**HISTORIC  
PRESERVATION  
11.1 REVIEW****PROJECT NAME:** Casper Supply Co. / Parts Central**PROJECT ADDRESS:**  
415 Main Street**DESCRIPTION OF REQUEST:**

## HISTORIC PRESERVATION 11.1 REVIEW

Project Name: Casper Supply Co / Parts Central

Project Address: 415 Main Street

# MAIN FLOOR

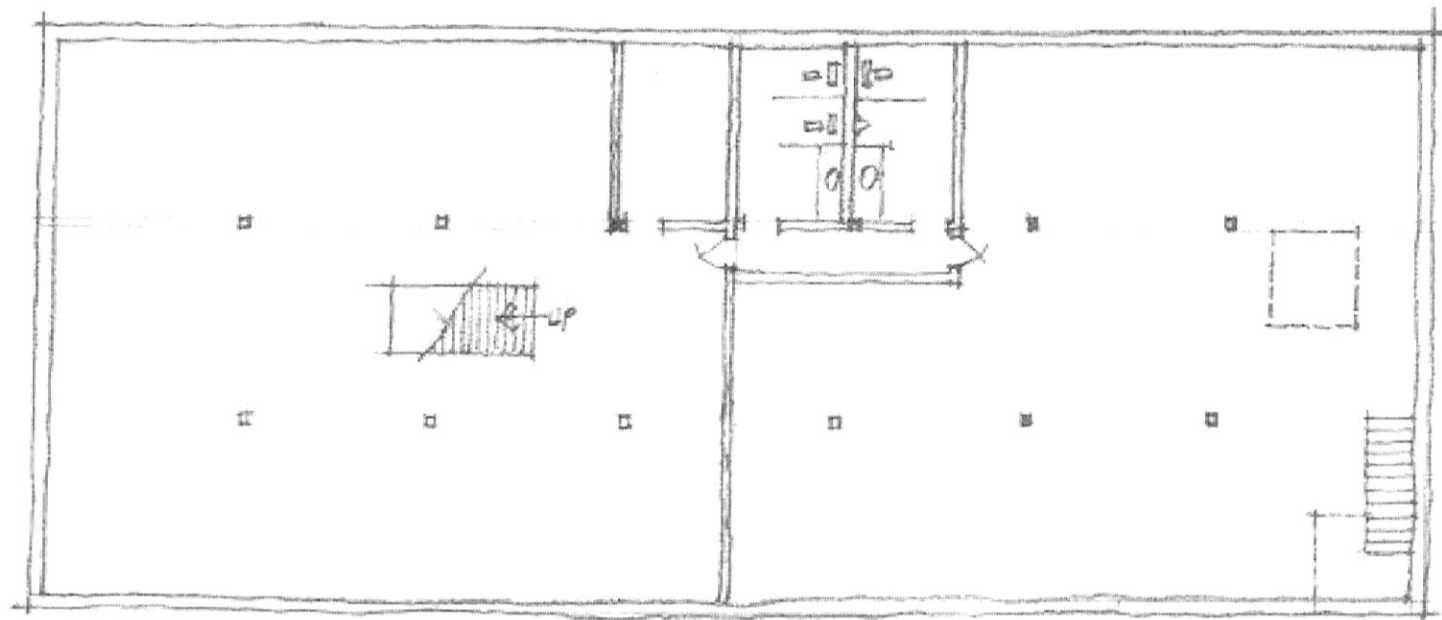
2. Interior:
  - a. Demolition: We propose to remove existing offices and restrooms on both floors because they don't meet code or ADA guidelines.
  - b. Walls:

- i. We intend to retain the existing wall that separates the main floor into two areas. The rear area will be developed into the clients' offices. The front area will remain undeveloped until the area is leased, except for the display wall and the enclosing of the stairs.

- c. Display Shelves: A wall with display shelves will be located approximately where the counter and display shelves were located previously.
  - d. Ceiling:

- i. Throughout the main floor we intend to use acoustical tile ceiling with the same dimensions and layout as the existing ceiling tiles.
  - e. Light Fixtures: We plan to refurbish and reuse the historic art deco light fixtures in the front reception area.

- f. Elevator: The hoist will remain in place and a skylight will be installed on top of the shaft.
  - g. Stairs:
    - i. The existing stairs will be enclosed in wood and glass for reasons of security, sound separation and HVAC zoning.

- ii. A new set of stairs will be added to the rear of the building in order to have a second egress route out of the basement.
  - h. The interior construction will be wood stud and gypsum board with wood doors, frames and baseboard and crown molding in accordance with the building style. There will be glass above the interior walls to distinguish the new layout from the old construction.

BASEMENT

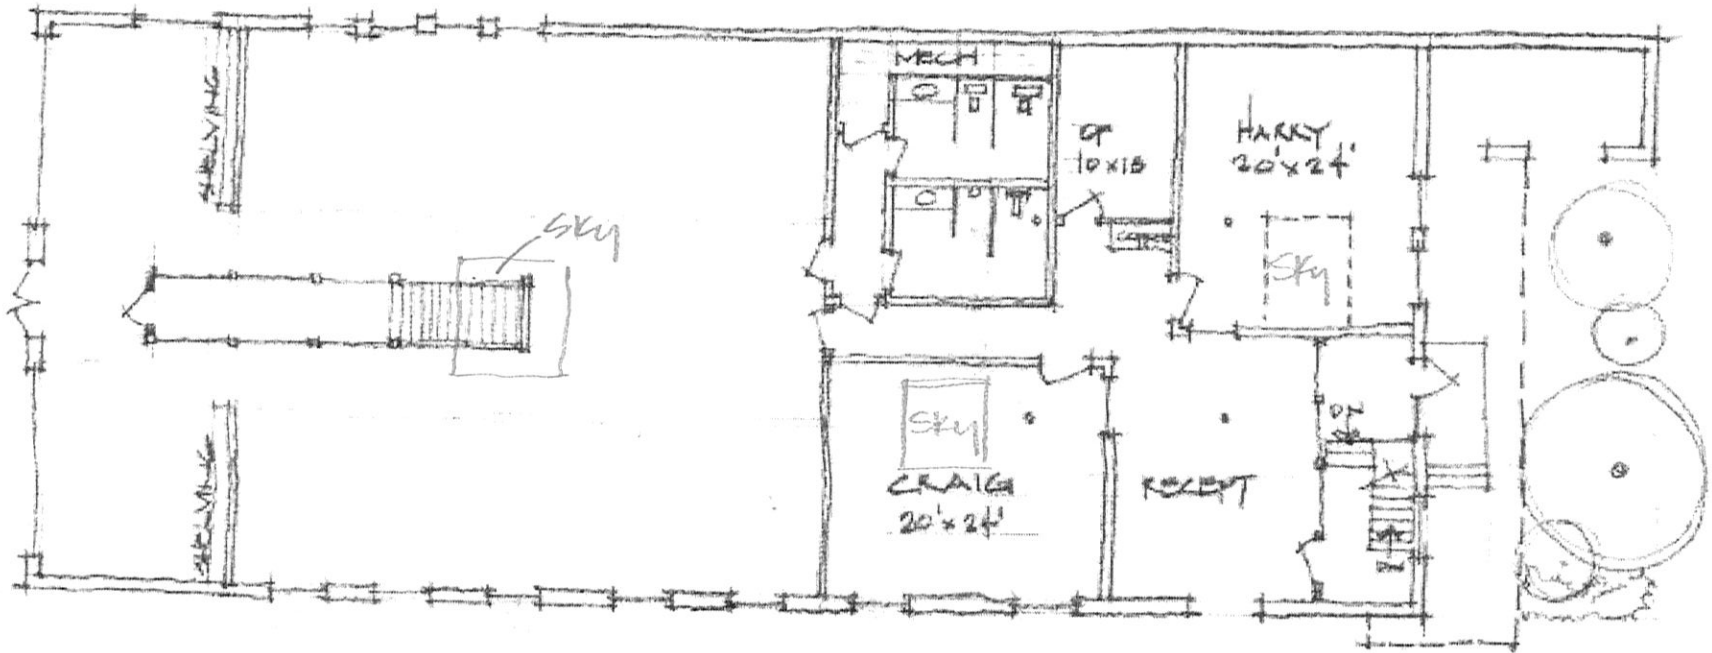
- ii. We intend to leave the existing exposed clay brick walls as they are.
    - iii. In the basement, the exterior walls will be furred and insulated.
